**TRANSMITTAL SHEET**

This sheet transmits Revision 5 to Service Bulletin SB34-15.

TITLE NAVIGATION - 9500 POUND ZERO FUEL WEIGHT INSTALLATION

To allow a zero fuel weight of 9500 pounds.

Figure 1. 9500 Pound Zero Fuel Weight Option Installation (Sheet 1 of 2)

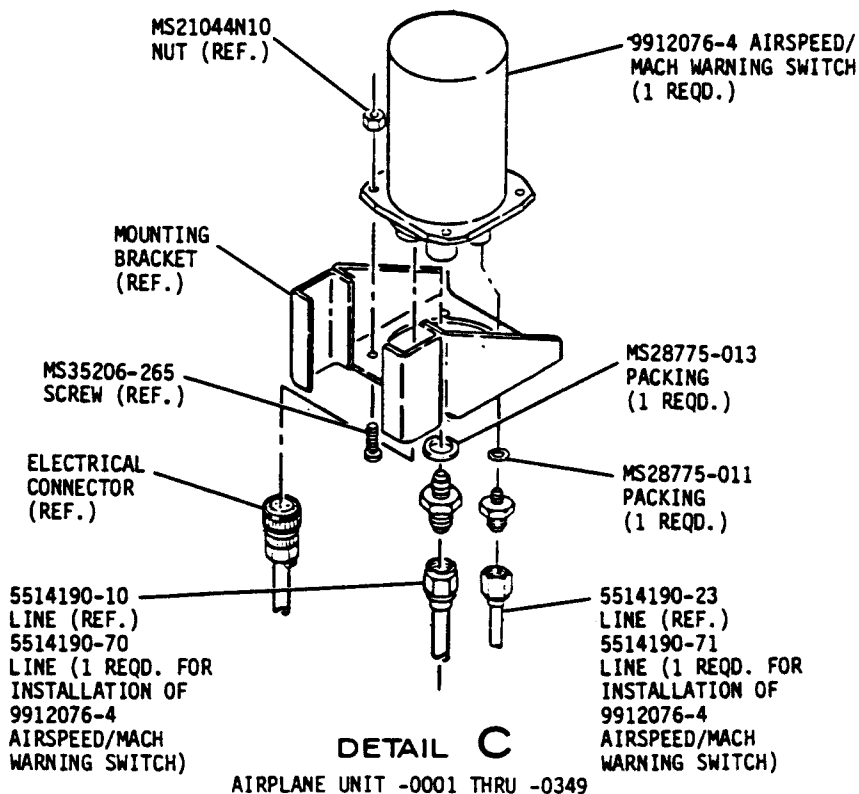
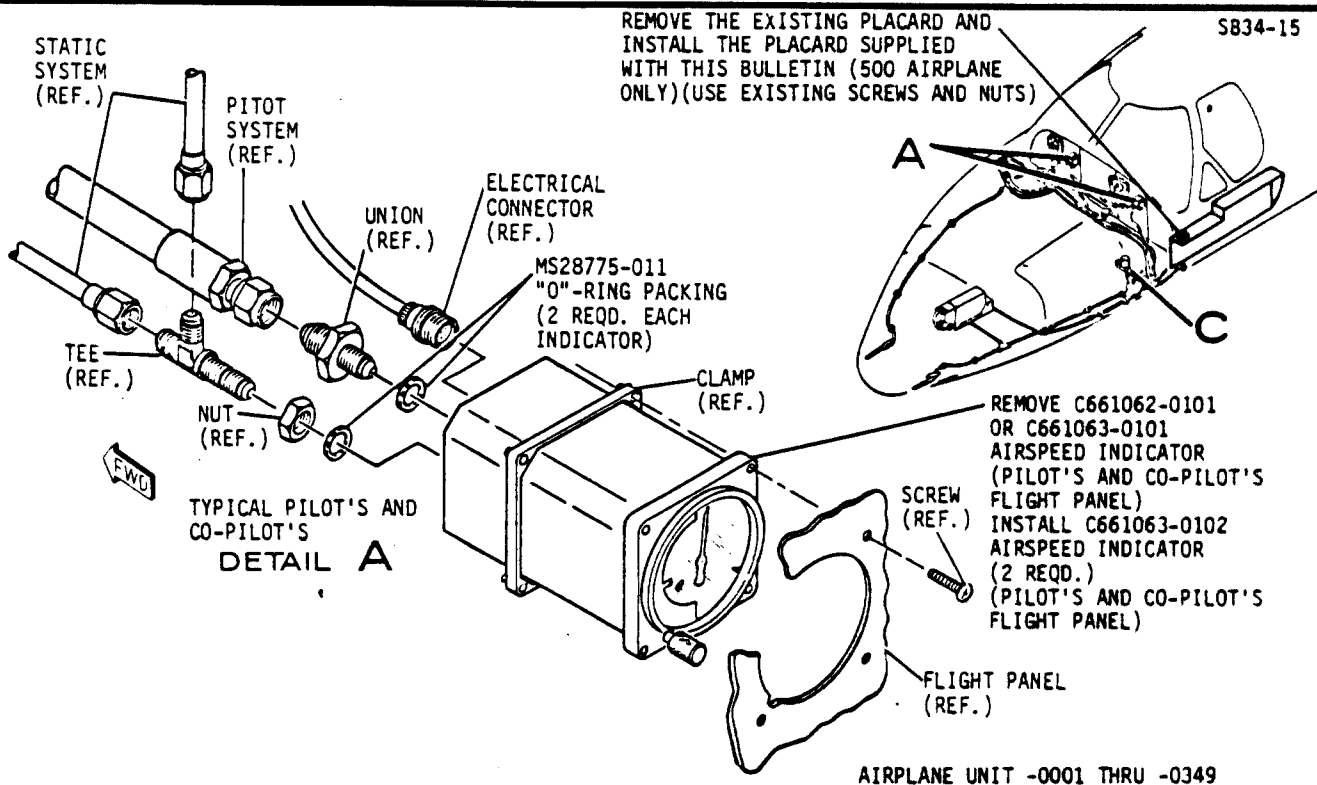
2. Remove both the existing mach/airspeed indicators. (Refer to the Maintenance Manual, Chapter 34, Mach/Airspeed Indicators - Removal/Installation.)
  - A. (Refer to Figure 1, Sheet 1, Detail A.) Airplanes -0001 thru -0349, remove the C661062-0101 or C661063-0101 Mach/Airspeed Indicators left and right. Retain removed hardware. Discard packings.

3. Install new mach/airspeed indicators. (Refer to the Maintenance Manual, Chapter 34, Mach/Airspeed Indicators - Removal/Installation.)
  - A. (Refer to Figure 1, Sheet 1, Detail A.) Airplanes -0001 thru -0349, install C661063-0102 Mach/Airspeed Indicators in place of removed C661062-0101 or C661063-0101 indicators, using existing hardware and new packings furnished in this bulletin.

Figure 1. 9500 Pound Zero Fuel Weight Option Installation (Sheet 2)

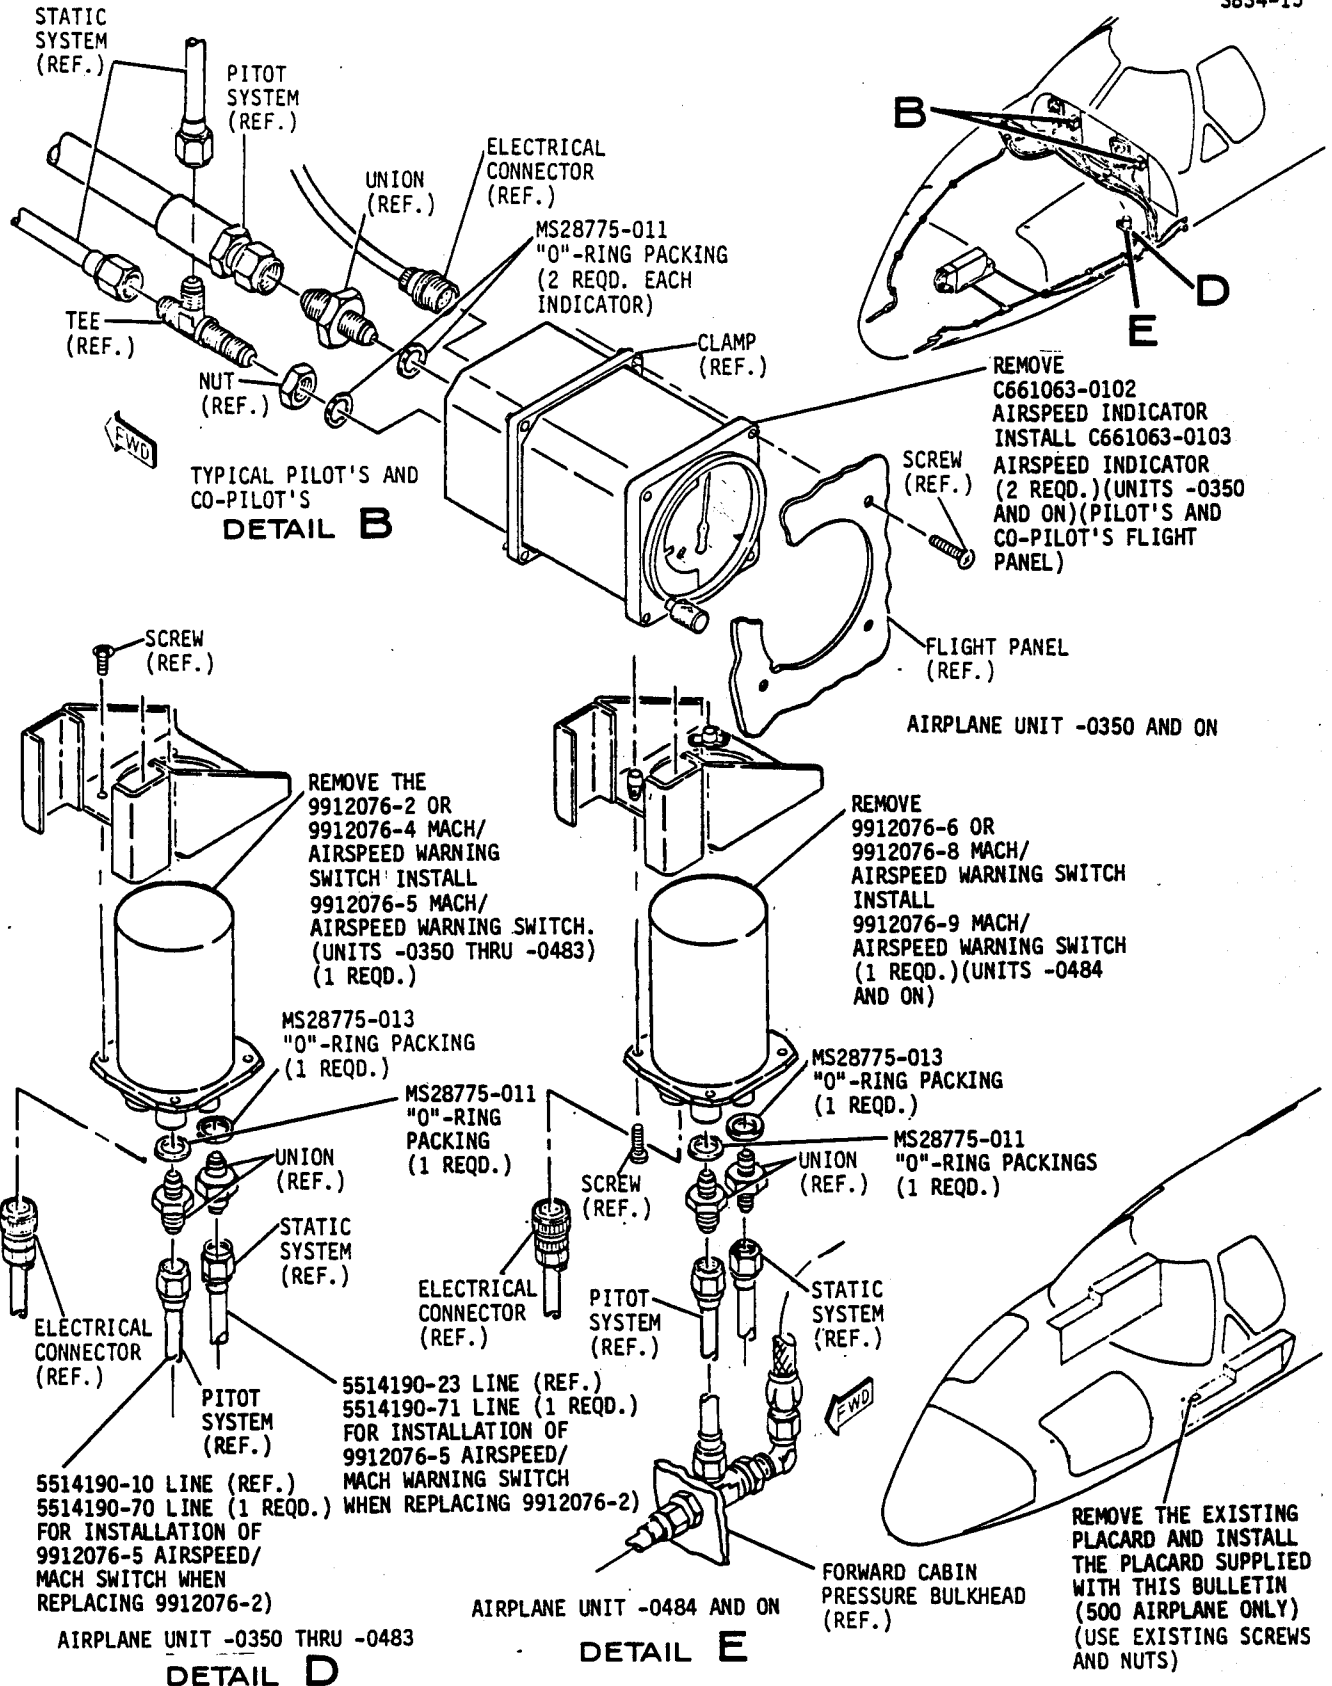
- B. (Refer to Figure 1, Sheet 2, Detail B.) Airplanes -0350 thru -0689, remove the C661063-0102 Mach/Airspeed Indicators left and right. Retain removed hardware. Discard packings.

- B. (Refer to Figure 1, Sheet 2, Detail B.) Airplanes -0350 thru -0689, install C661063-0103 Mach/Airspeed Indicators in place of removed C661063-0102 indicators, using existing hardware and new packings furnished in this bulletin.
